**Block 6 - Hotel**

## Proximity of buildings - street hierarchy

Proposed plan showing pedestrian access to Bottleworks Square

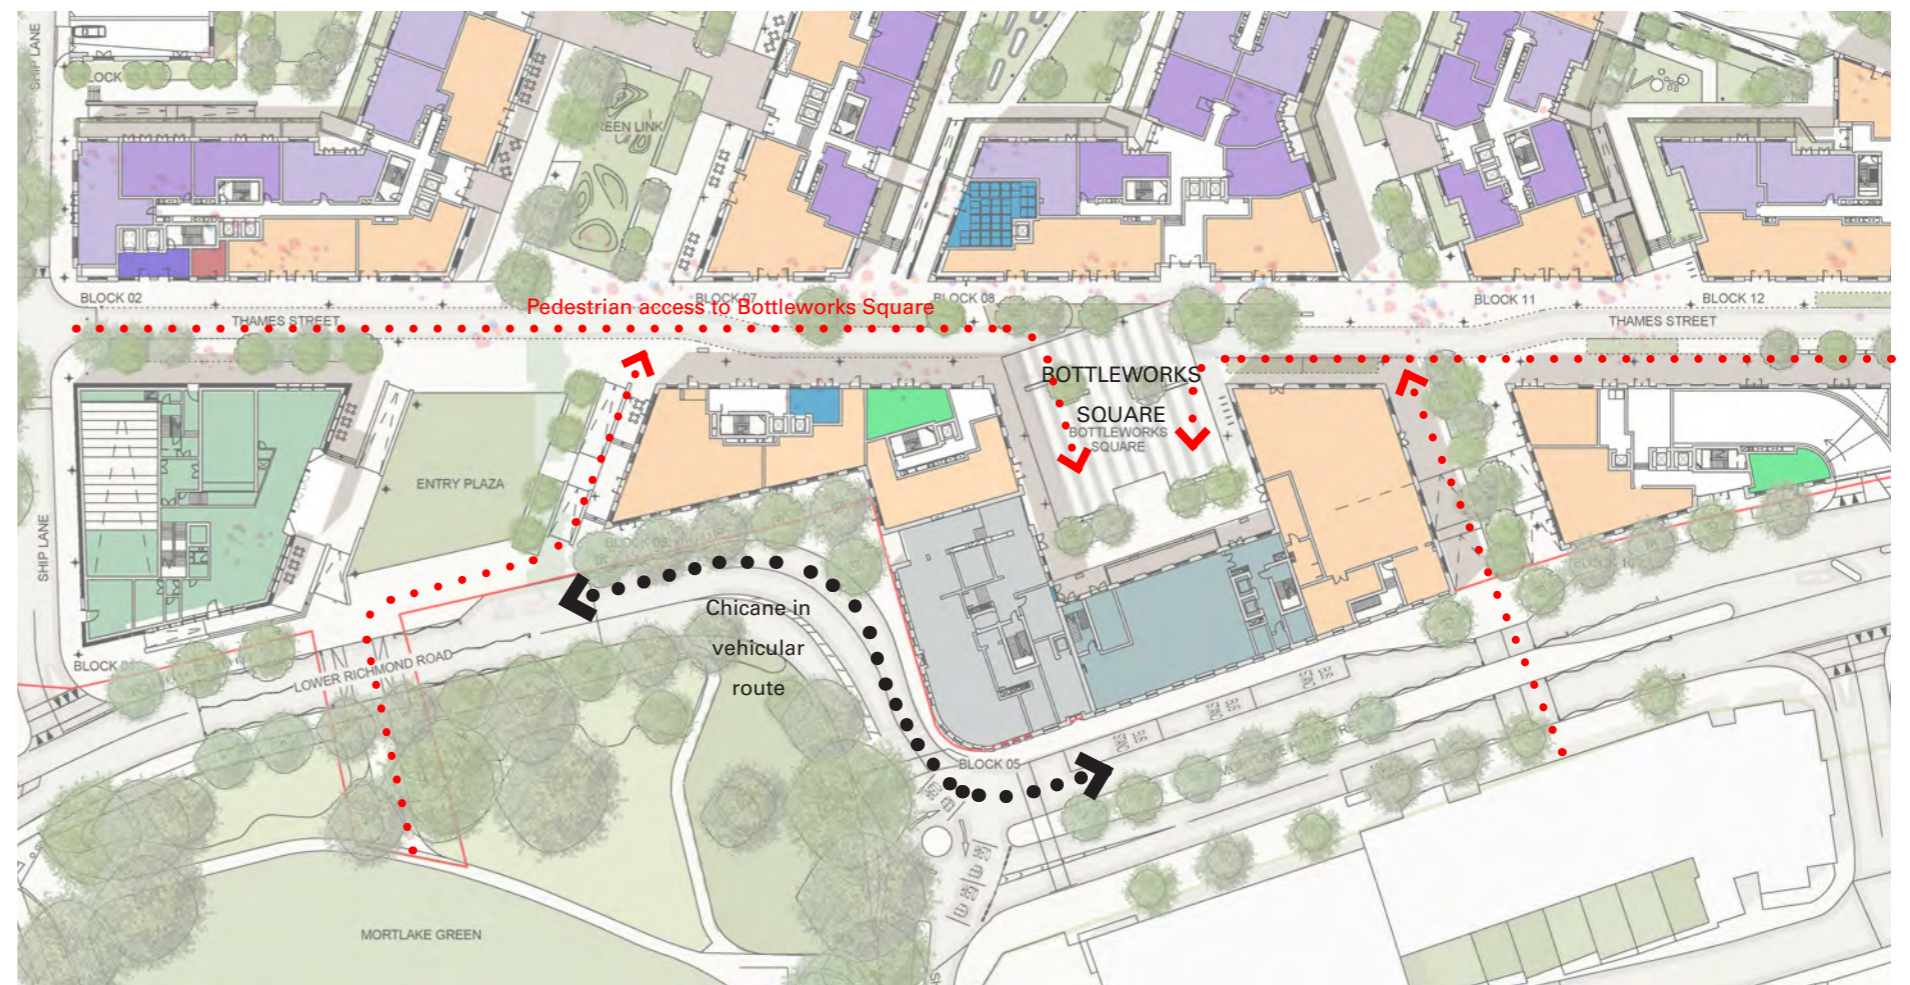
2. Access to Bottling Square seems rather torturous. How does access to square work?

We would remind you that the green link had originally been proposed to begin at the corner of Lower Richmond Road (to the north west of the hotel). While this proposal stemmed from the Planning Brief diagram, it became apparent that a series of traffic constraints and safety issues make it unfeasible to provide a route in this location. It is these safety issues that have guided the proposal to deliberately prevent pedestrians from cutting across this potentially dangerous chicane in the existing road.

The Bottling Square is instead conceived as a public space that is accessible off the main new 'High Street' route. This widened public space serves to add variety to the streetscape and provide the potential for events to be held in the space.

It is not unusual to come across an 'unexpected' public space within a townscape - a space that is not immediately apparent within the townscape on approach from the periphery of the area. Many British and European cities benefit from strong urban spaces such as these and notable example is St Christopher's Square in Central London.

Revised east elevation of hotel

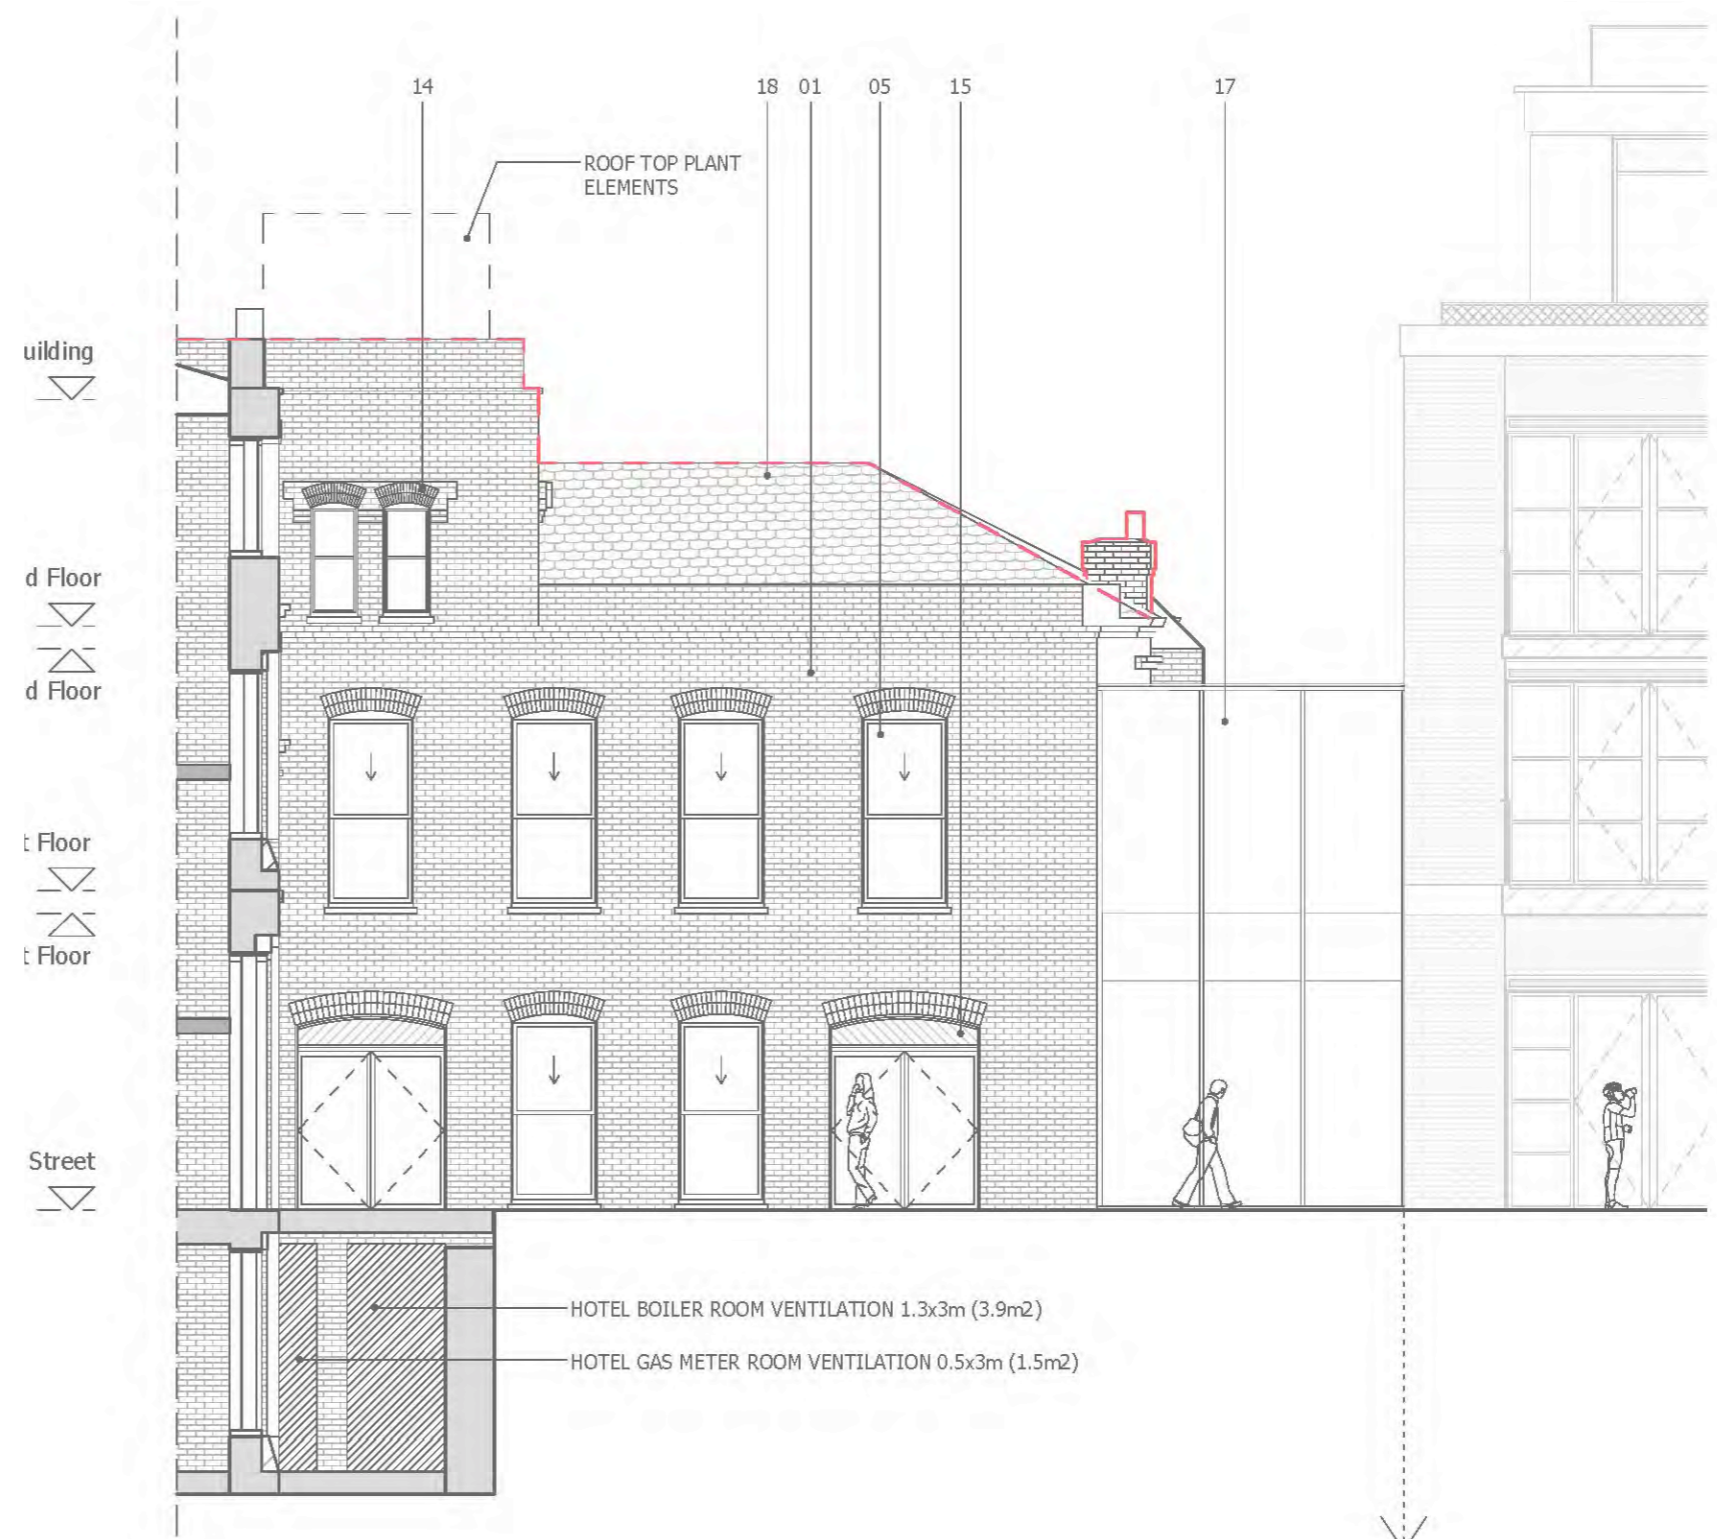
- BTM should stand independently; side elevation of this BTM should also be retained. Provide visualisations of glazing between Block 5 and 6 to justify addition.

The hotel building has been deliberately joined to the proposed adjacent residential building (B6) to prevent pedestrians jay walking across the potentially dangerous chicane in the road. The buildings are joined by a two storey high glazed link element that is subservient in appearance to the brick buildings it joins. This glazed link is proposed to serve as a double height restaurant/bar space that is part of the hotel. The detailing of the glazed façade will be minimal (with silicone joints as opposed to cover caps) and the brick facades of both adjoining buildings will be exposed internally within the restaurant/bar space. The existing north façade of the hotel building is proposed to be retained and adapted to suit the requirements of the new hotel function.

Revised west elevation of hotel

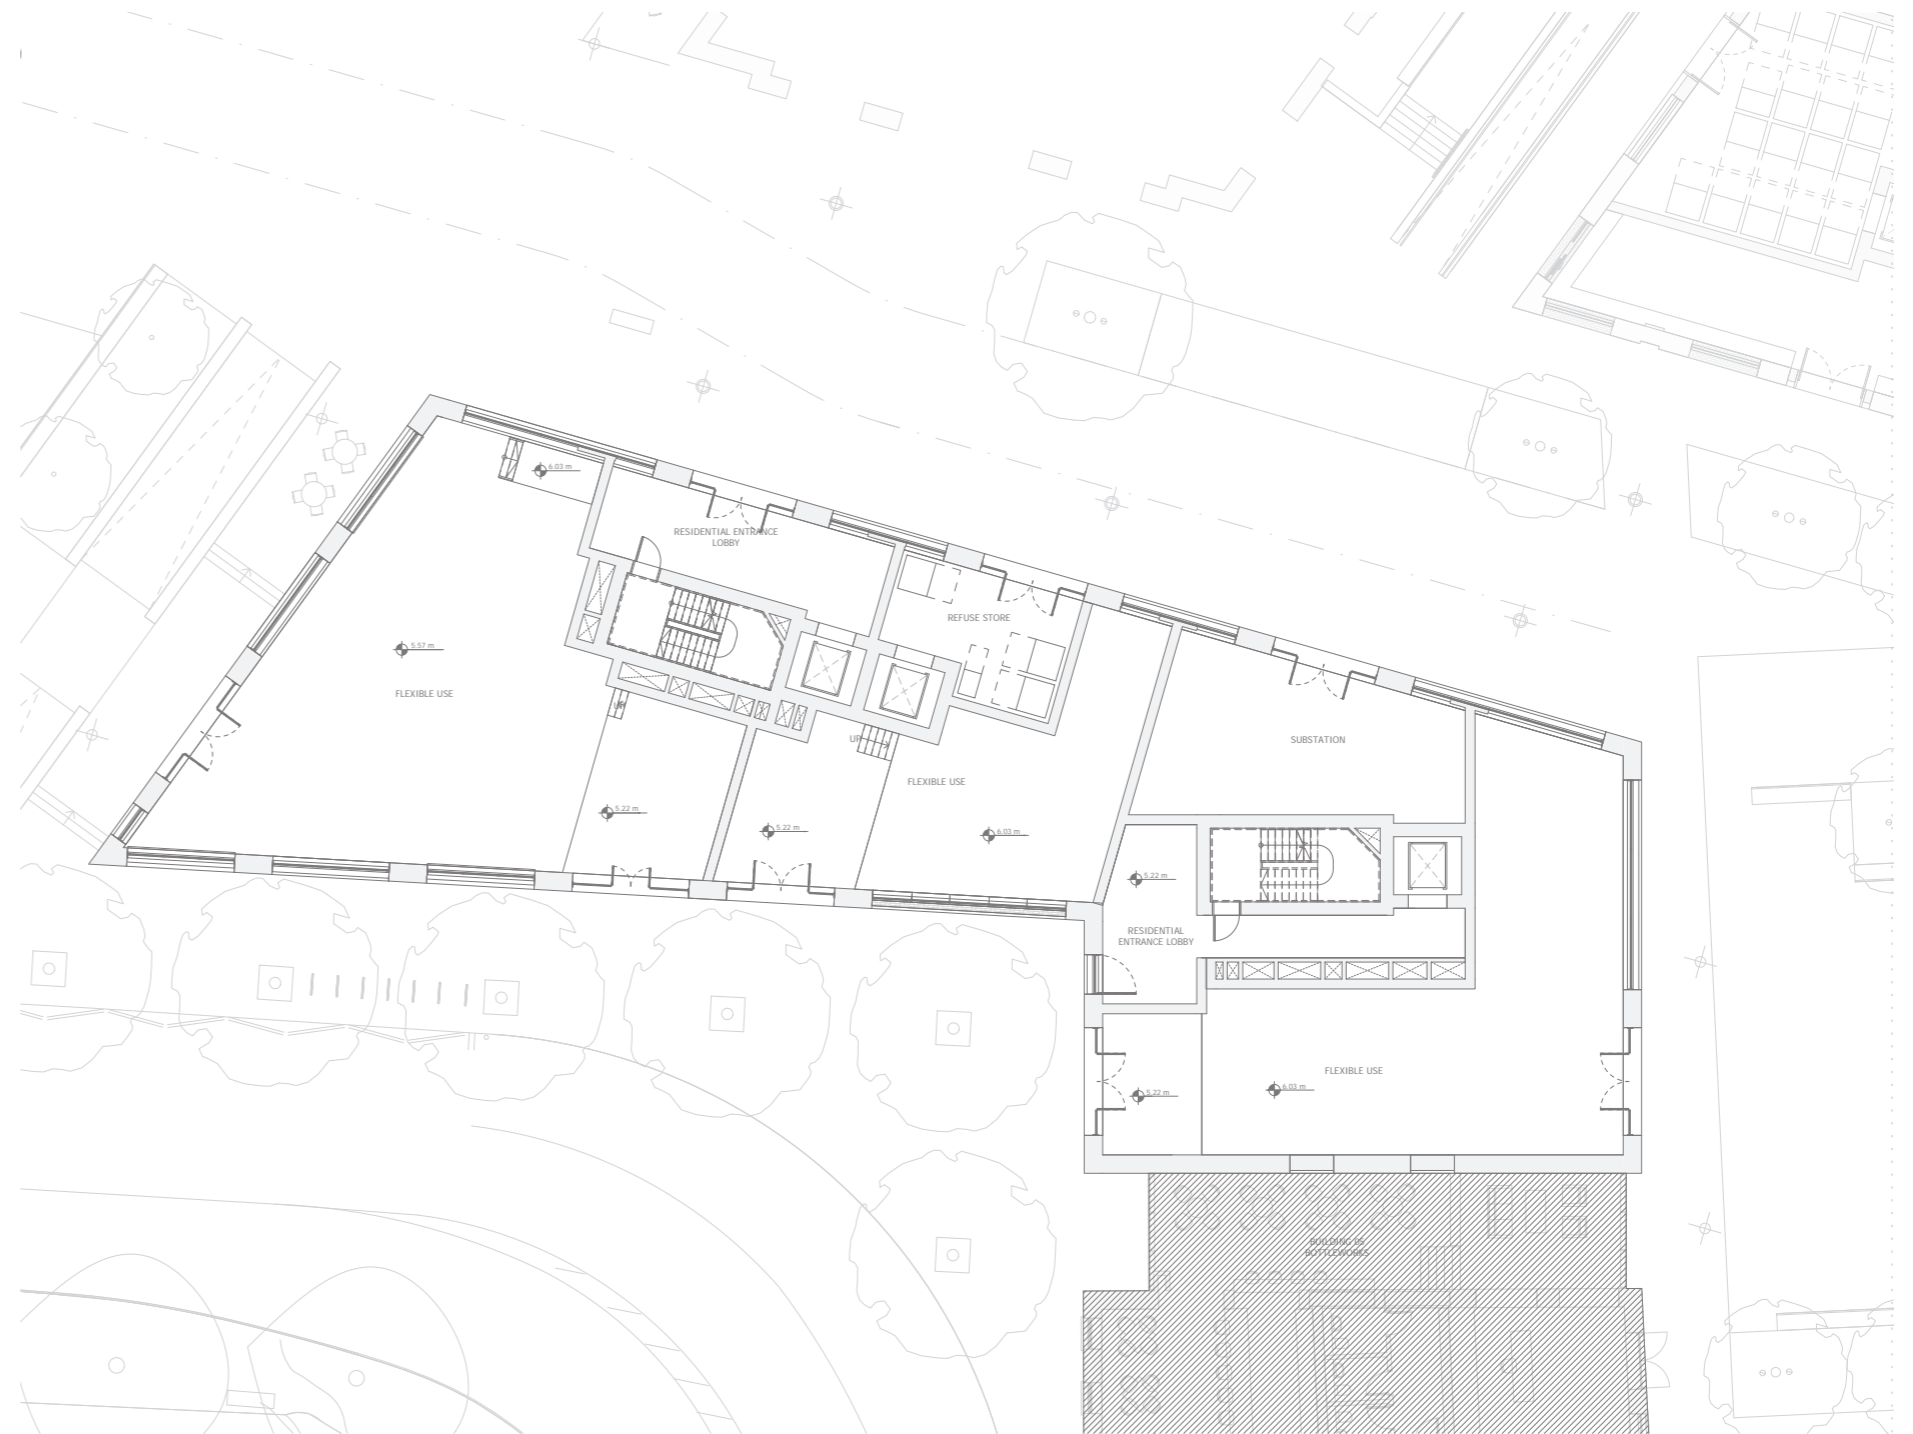
10. Remove glazed balustrade at roof level.

The roof level balustrade was proposed as a means of edge protection (from risk of falls) to any maintenance personnel when accessing roof top plant. We would not recommend removing this balustrade since this would pose a health and safety risk.

Building 6 - revised south elevation

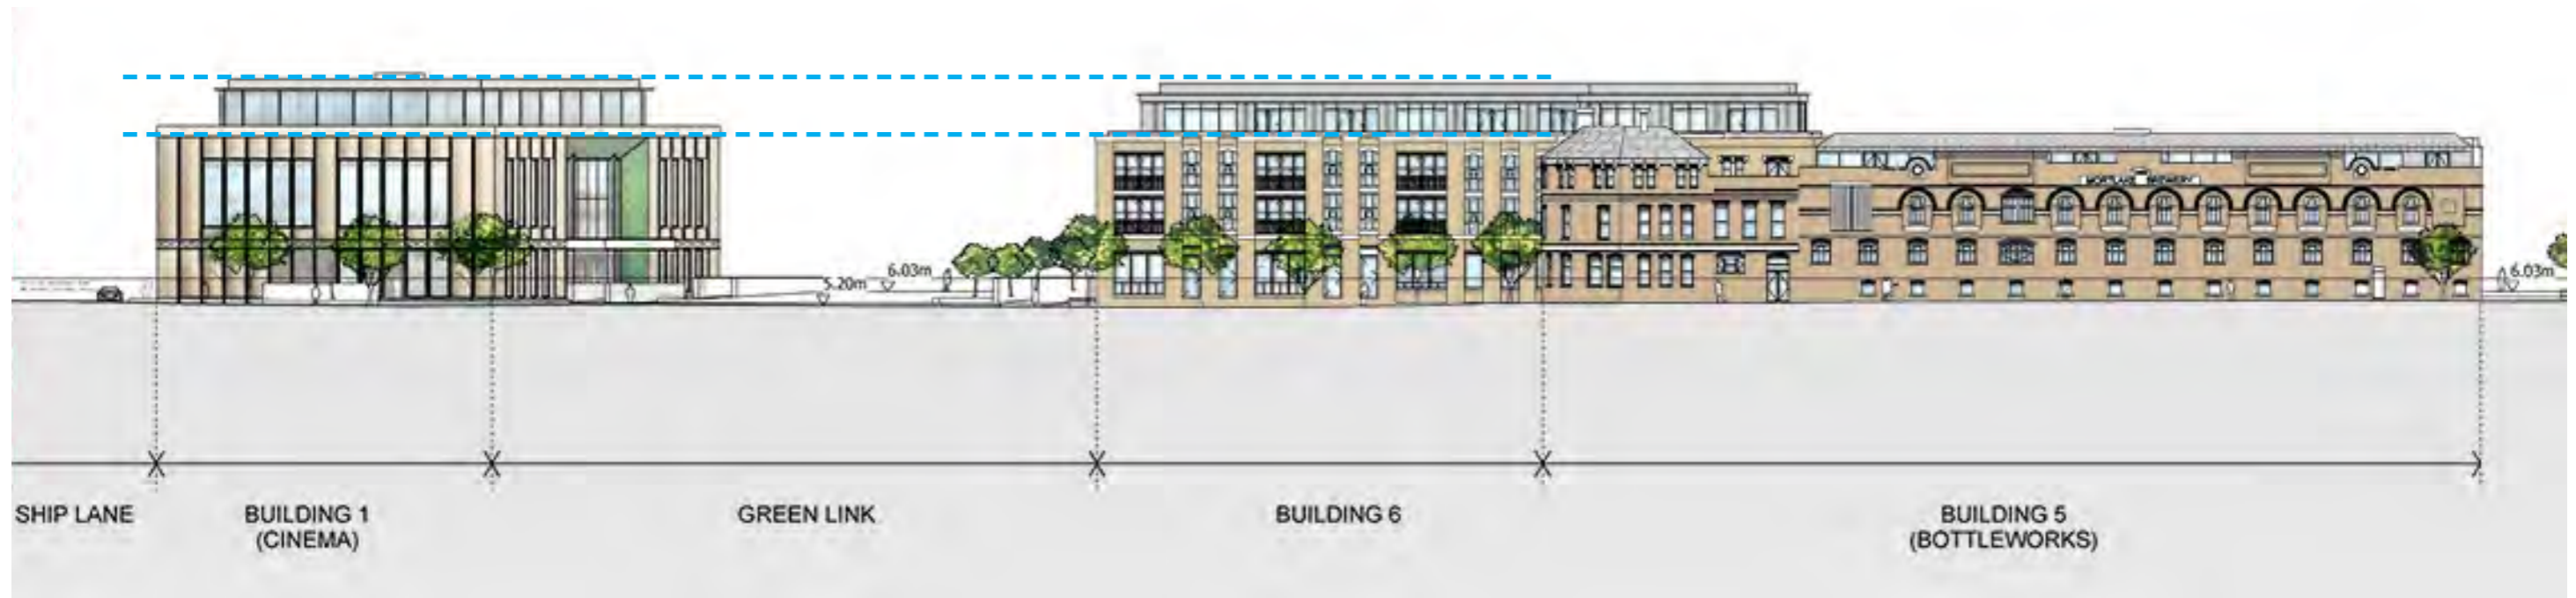
11. South elevation – poor relationship with street frontage in response to being higher. It has no active frontage/ access. Reconsider.

12. North elevation – poor relationship with Thames Street – entrance, refuse, substation – lack of frontage.

The proposed south elevation of Building 6 is three plus one set back storeys high (consistent with the height that wraps around the corner to meet the hotel building). The heights of this building are proposed to align with those of the cinema building, which sits on the opposite side of the entrance to the 'Green Link'.

The ground floor level of this building has been set at a level to provide level access from the middle of the frontage facing the green link. As a consequence, the level sits approximately 600mm above the pavement on the south elevation. Flexible use space is proposed along the entire frontage of the ground floor level that faces on to Lower Richmond Road. This area of façade is largely glazed and is only interrupted by vertical brick piers that come down to meet ground level. It therefore offers significant expanse of active frontage.

We do however recognise that the continuation of all brick piers down to ground level is limiting the width of available flexible use frontage. We therefore proposed that selected intermediate piers are omitted at ground floor level in order to increase the amount of glazing.

The phasing of Development Area 1 necessitates a series of sub-stations strategically distributed across the site. One of these sub-stations is proposed at the base of Building 6. Unfortunately, the statutory and technical requirements mean the space must be ventilated, therefore grilles are proposed to this secure enclosure. The metalwork grilles to these sub-stations could be fabricated to bespoke designs and could be conditioned.

The quantum of residential units also necessitates that minimum refuse storage (and collection) standard are met. The size of this refuse store has been sized according to the relevant standards and must be within a maximum distance of the refuse vehicle route (along the new High Street). It is also worth noting that refuse vehicles must also be able to navigate the route in a forward motion.

These constraints have resulted in the North elevation being largely occupied by utilitarian spaces. However, we have endeavoured to intersperse flexible use and residential entrances between the more utilitarian elements and the entrance lobby to the eastern core has been re-configured to increase flexible use frontage facing Bottleworks Square.
